INSTRUCTION TO SERVICE

ITS: 6075	
SECTION:	Chassis
WRITTEN BY:	Kevin Robinson
SUBJECT:	MiDi – remove and replace block heater

Figure 1: Location of Engine Block Heater

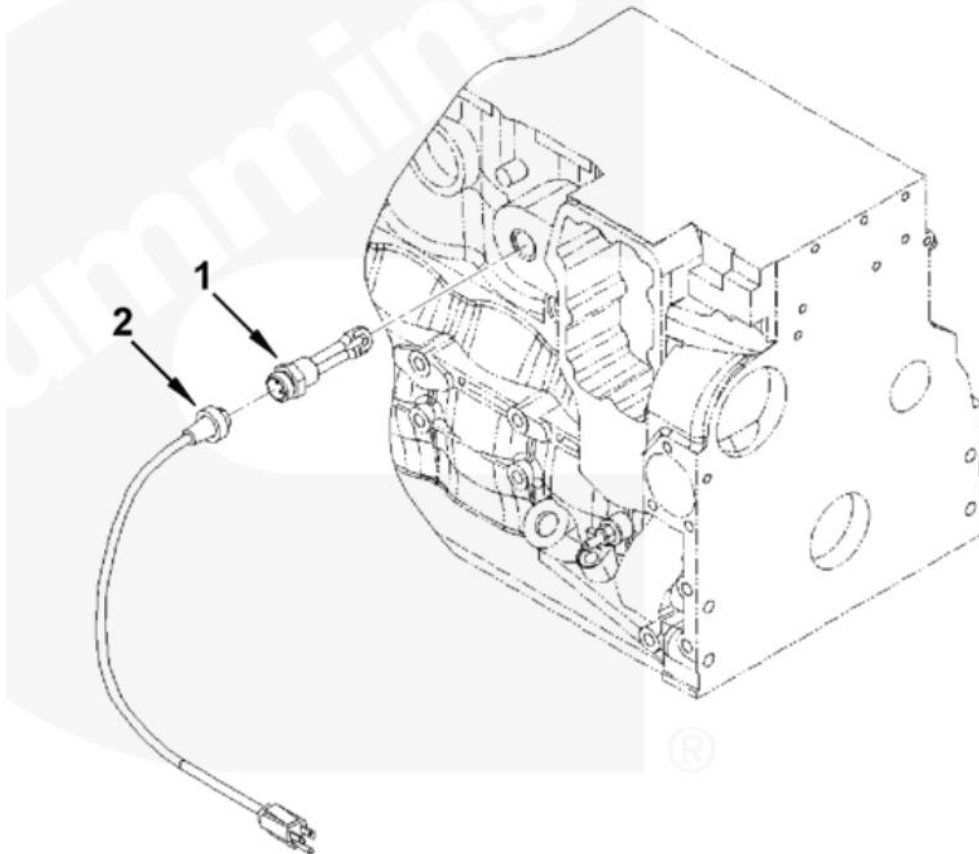
1. Turn the main battery disconnect switch to the “OFF” position.
2. Open the engine access door.
3. Locate the block heater on the engine block.
4. Disconnect the existing cord and discard.
5. Using a wrench, unscrew the existing block heater from the engine block.
6. Install the new engine block heater (NF PN A-664998) into the block, in the same spot the original was removed from.
7. Connect the new cord (NF PN A-664997) to the newly installed block heater and route to a location that is suitable for the end customer.
